Subject: **Modification Request for Section 404 Individual Permit, Individual Section 401 Water Quality Certification, Neuse Buffer Authorization, and Issuance of Tar-Pamlico Buffer Authorization** for the Rolesville Bypass from NC 96 (Zebulon Road) to SR 1103 (Flat Rock Church Road/Clifton Pond Road), Wake/Franklin Counties, Federal Aid No. STP-401(249), State Project No. 81403001, Division 5, TIP R-2814 C. Debit \$570.00 from WBS Element 34506.1.1.

Reference: Section 404 Individual Permit, issued July 14, 2009, USACE Action ID 2008-01316

Please see the enclosed revised permit drawings and impact summary sheets for the above referenced project.

PERMIT DRAWING
SHEET 1 OF 61

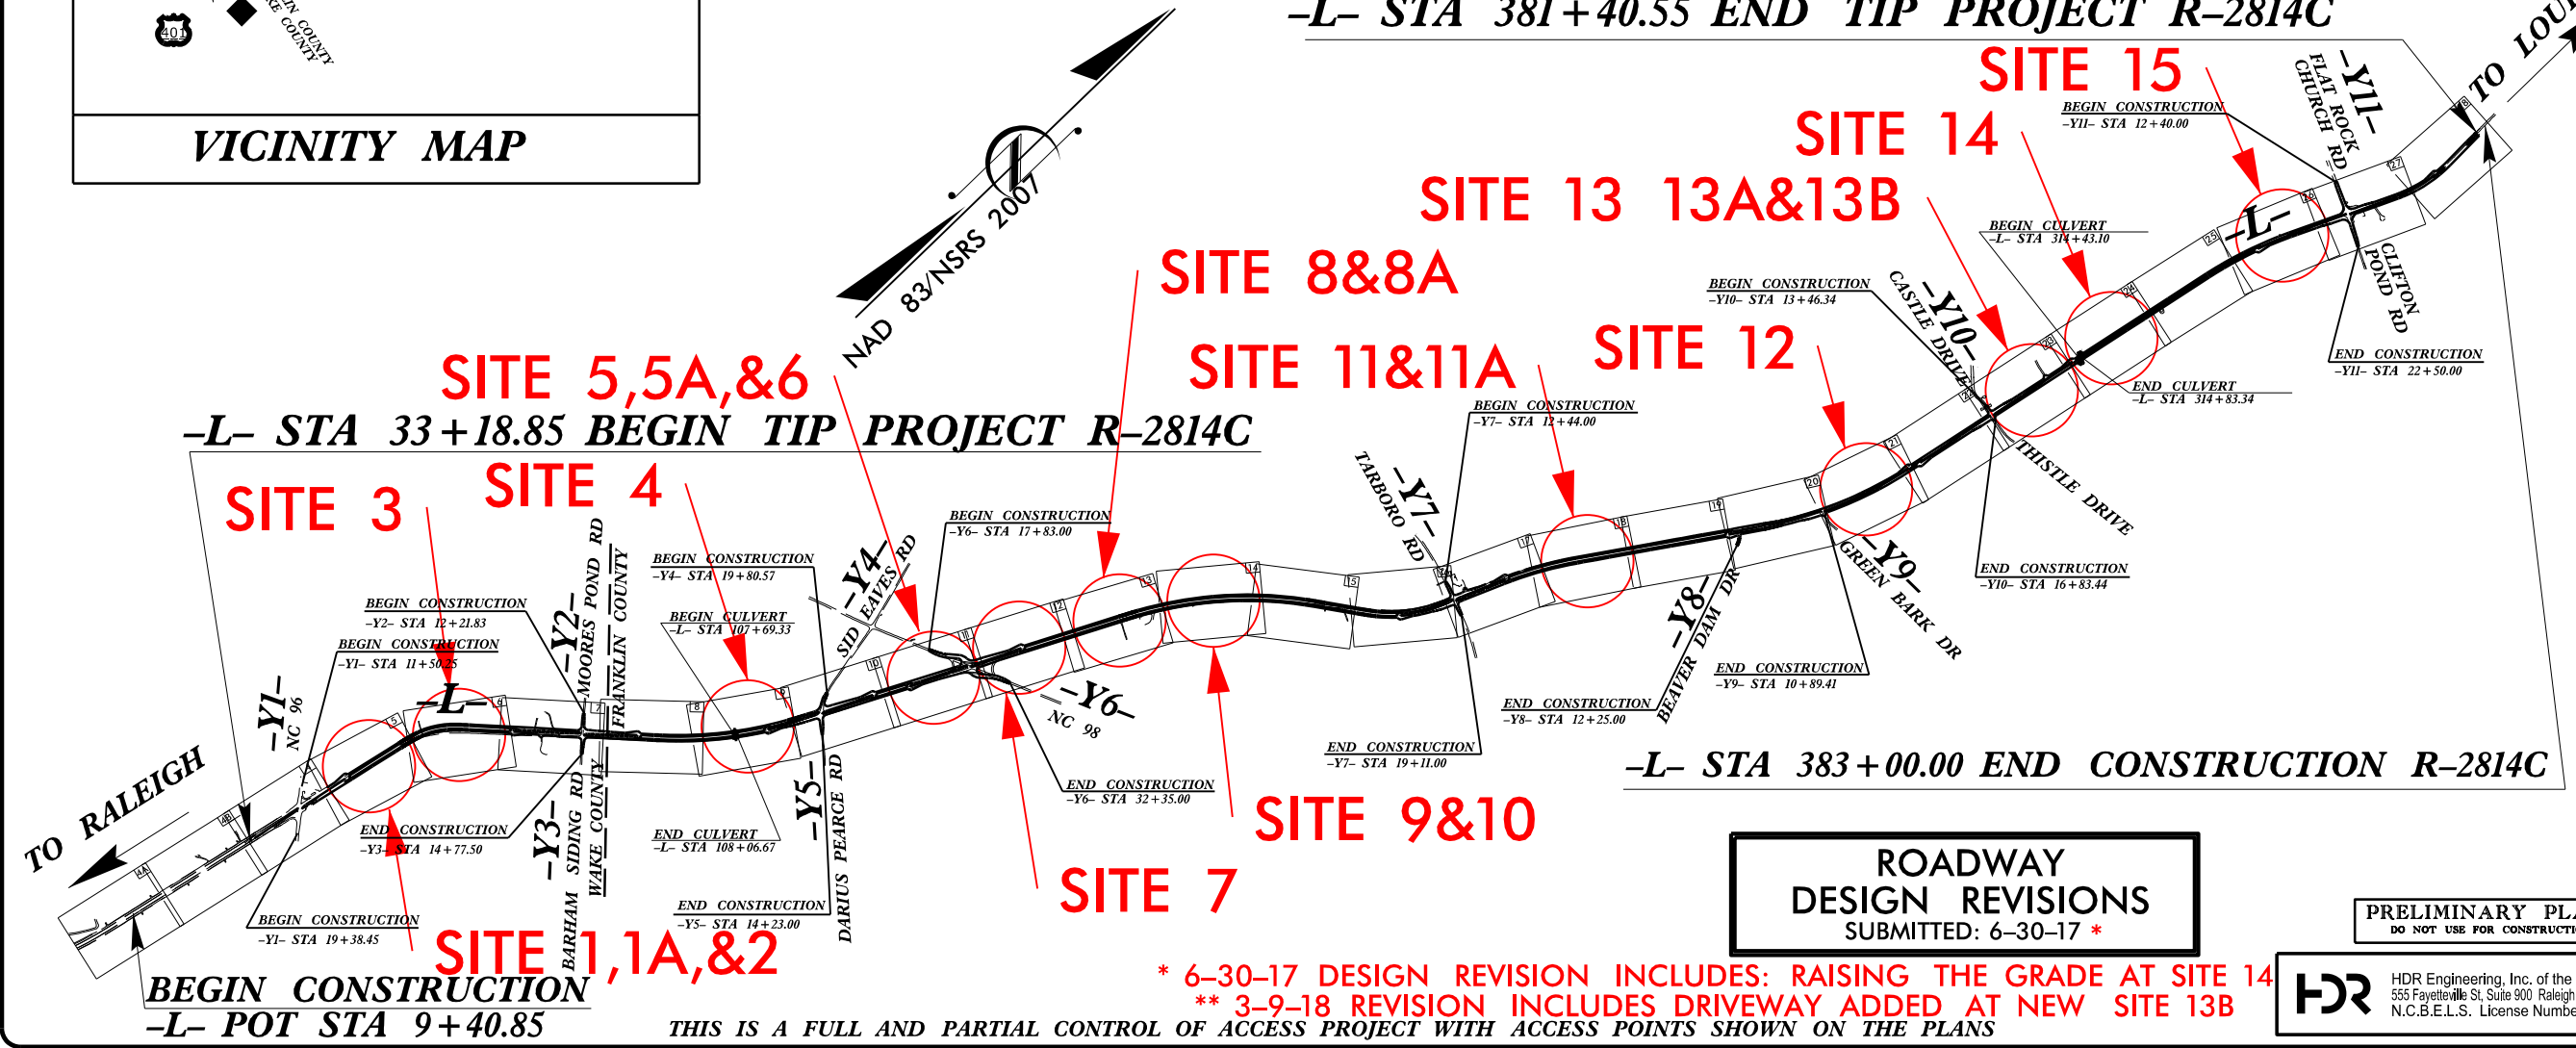
* 6-30-17 DESIGN REVISION INCLUDES: RAISING THE GRADE AT SITE 14
** 3-9-18 REVISION INCLUDES DRIVEWAY ADDED AT NEW SITE 13B

PERMIT DRAWING
SHEET 50 OF 61

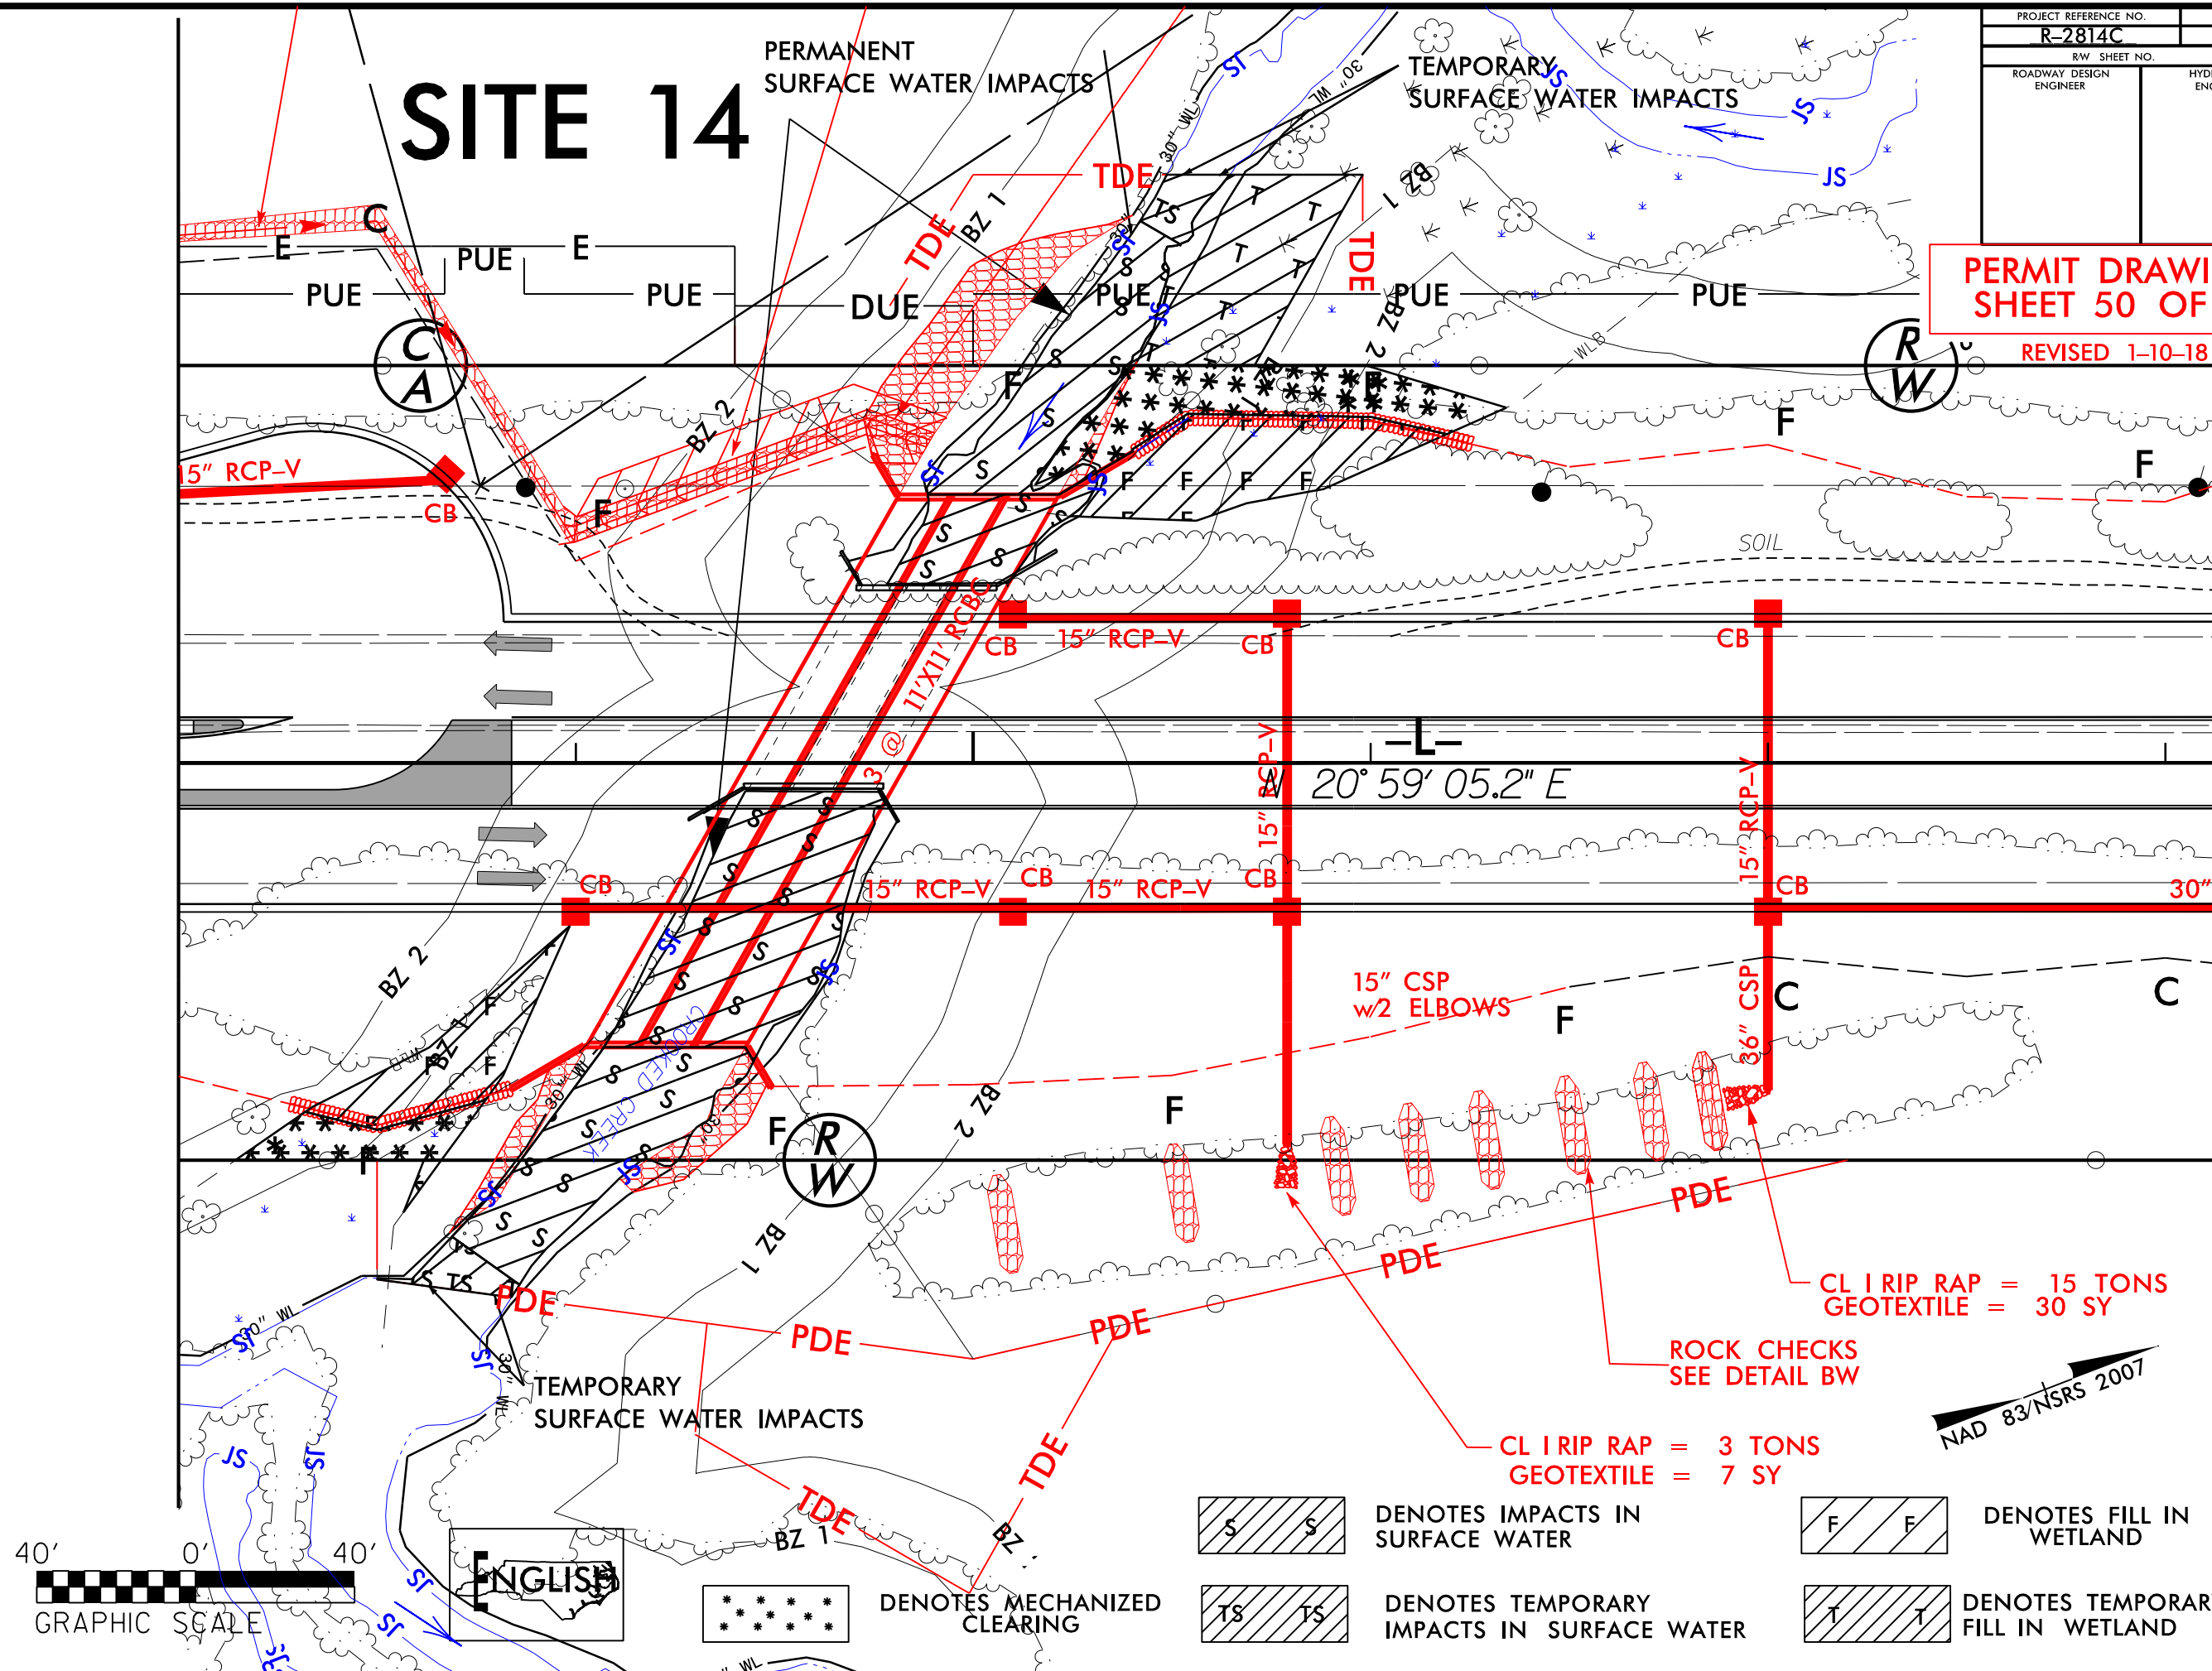
Also, the design has been revised at Site 14 (Sta. -L- 314+63 RT<). The raised grade at this site will result in an additional 0.01 acre of mechanized clearing in jurisdictional wetlands (Permit Drawing Site 14). Additionally, the raised grade will cause the proposed culvert to be lengthened by 5 linear feet. Bank stabilization at this site is adjusted for this increased culvert resulting in no net change in permanent stream impact.

REVISÉD 1-10-18

PERMIT DRAWING
SHEET 1 OF 23

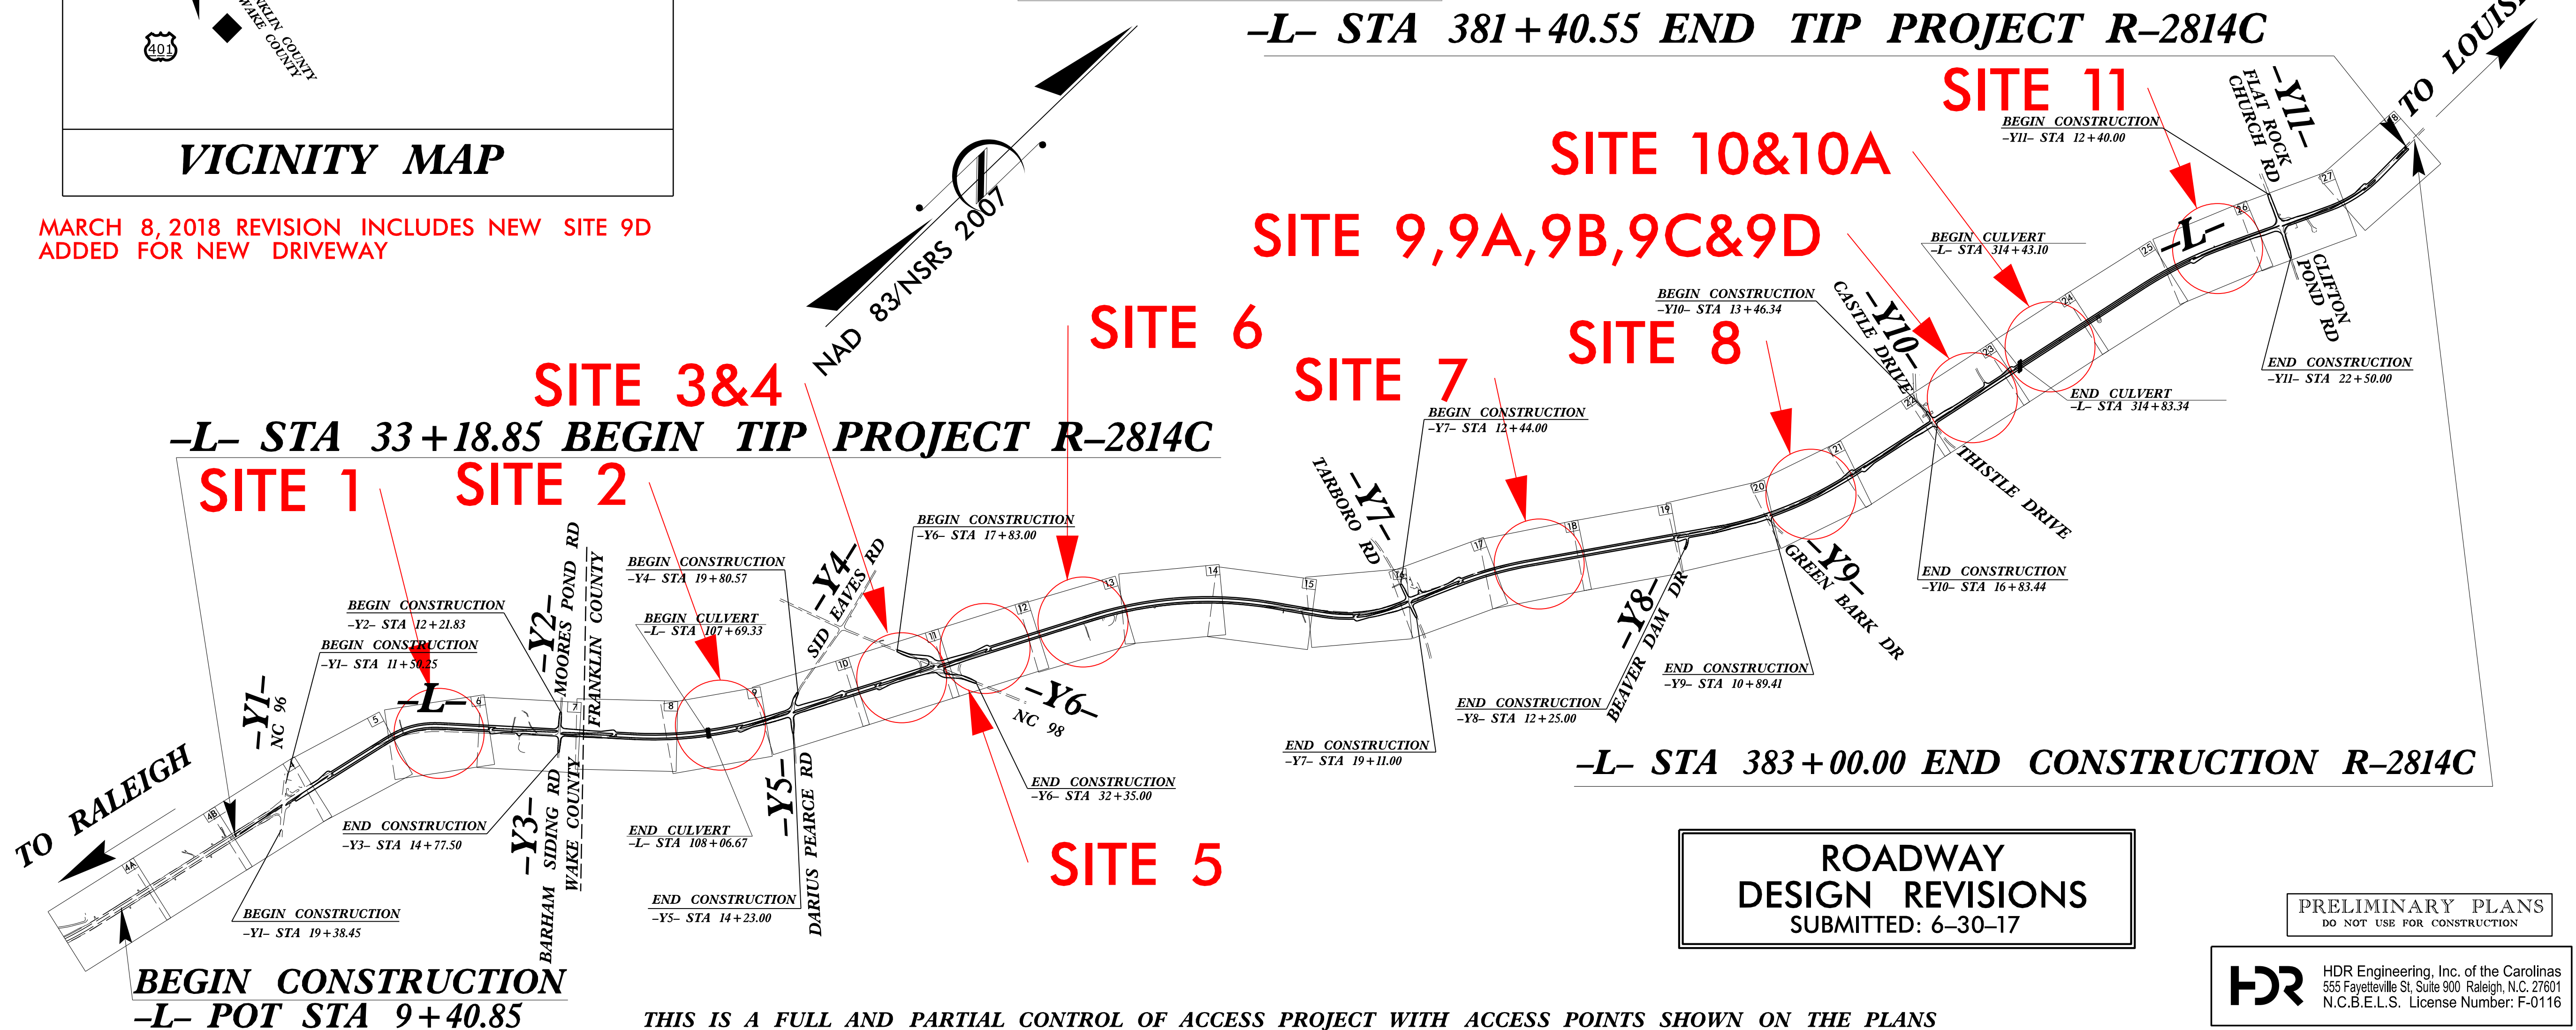
MARCH 8, 2018 REVISION INCLUDES NEW SITE 9D
ADDED FOR NEW DRIVEWAY
